Town of Hilton Head Island
Design Review Board Meeting
Tuesday, November 10, 2020 – 1:15 p.m.
AGENDA

DESIGN TEAM/DRB COMMENT SHEET

PROJECT NAME: 28 Shelter Cove Lane

DESIGN TEAM/DRB COMMENT SHEET

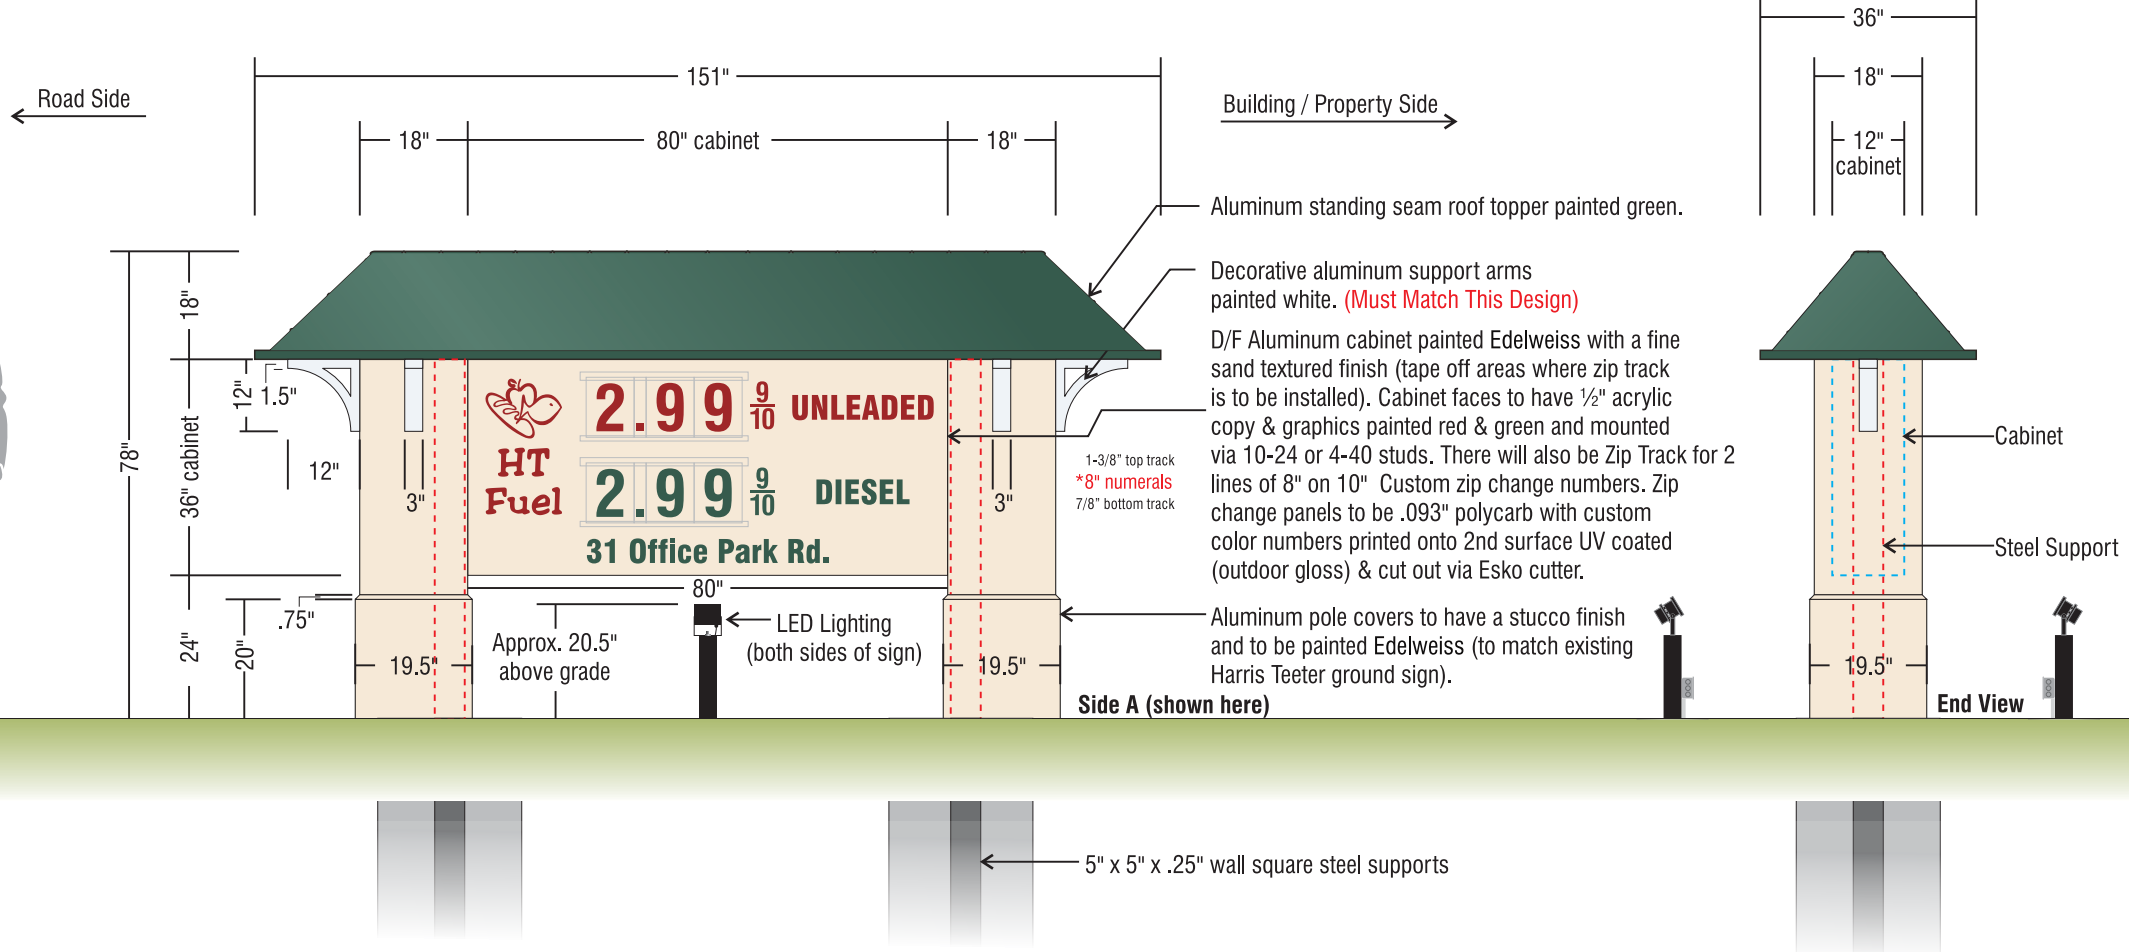
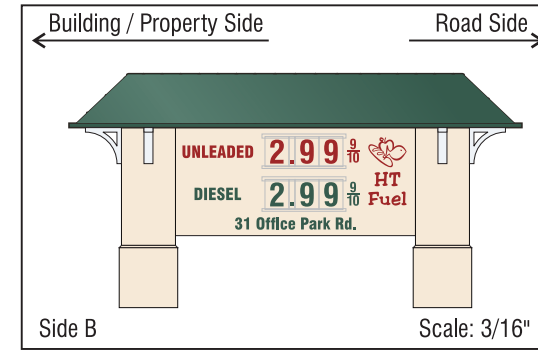
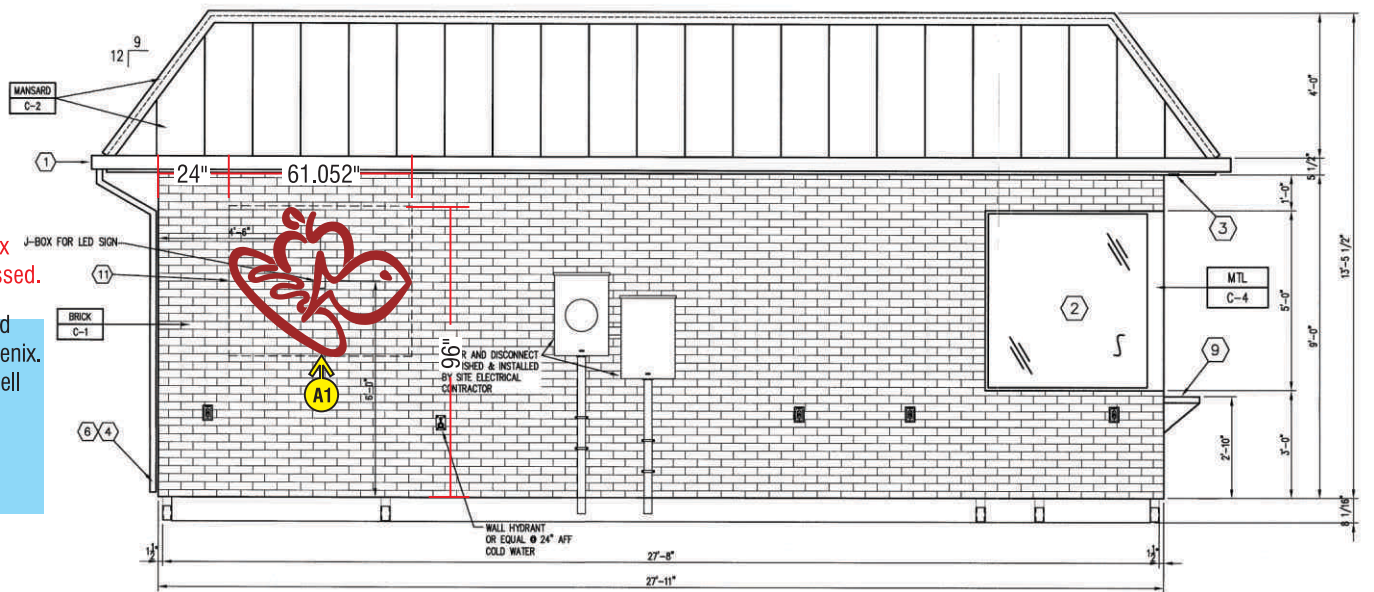
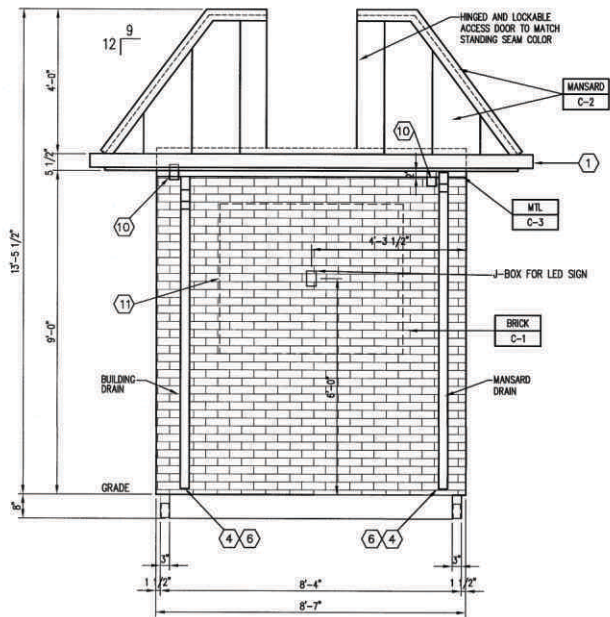
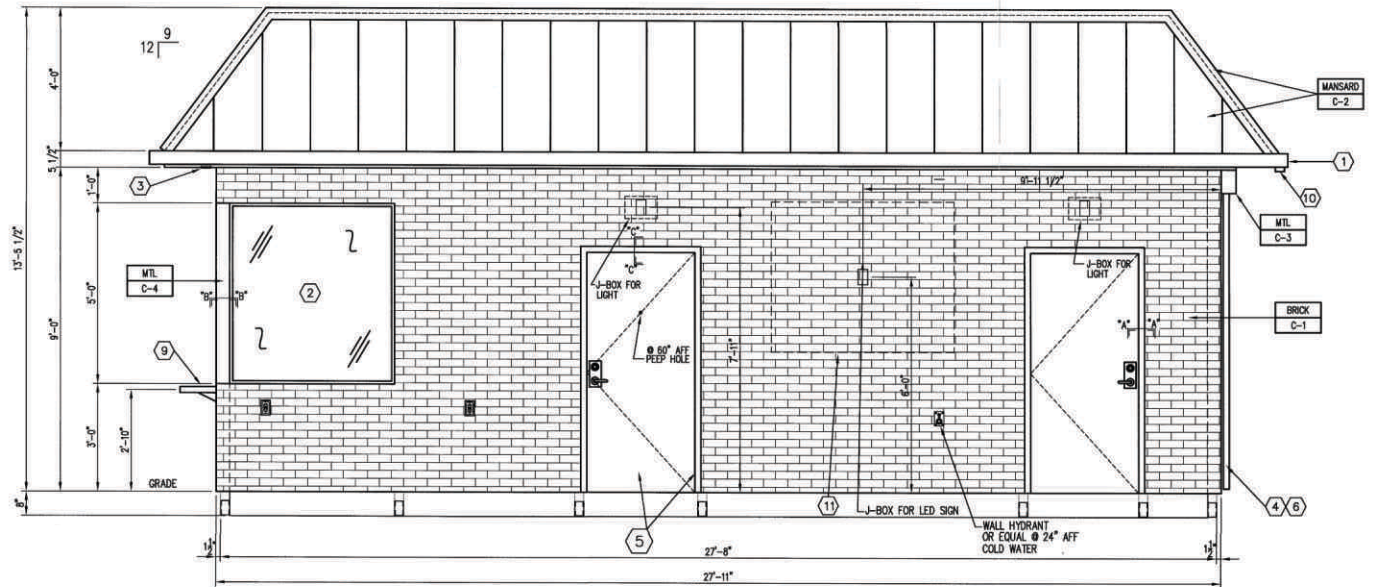
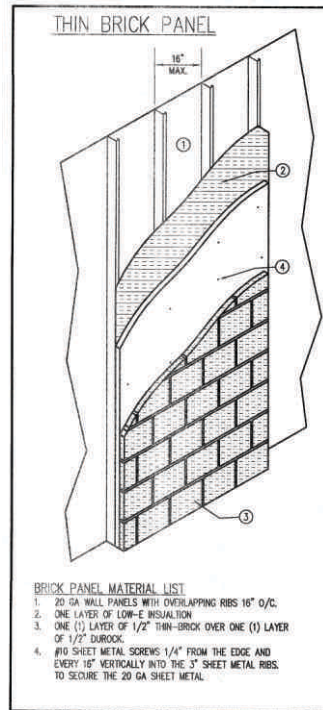
1. Logos on kiosk are not approved.
2. On the freestanding sign:
 - a. Change the sign face material from aluminum with applied copy and graphics to sandblasted 1" Cedar panels with 1 ½ inch border in Nebulous White to match the adjacent Harris Teeter sign. Leave surface directly behind changeable copy and tracks smooth.

- b. Change all copy to Sherwin Williams Iron Ore. Logo to remain as proposed.
 - c. Reconfigure the sign face to move the address to the top and add a 1 ½ inch vertical line between the business name/logo and the pricing information. Reduce copy size and adjust spacing on pricing side as needed. Address must be a minimum of 4" copy.

- d. Change up lighting to down lighting with recessed linear fixtures mounted underneath the roof element.
 - e. Landscape plan utilizing evergreen plantings to be prepared by staff with sign permit.
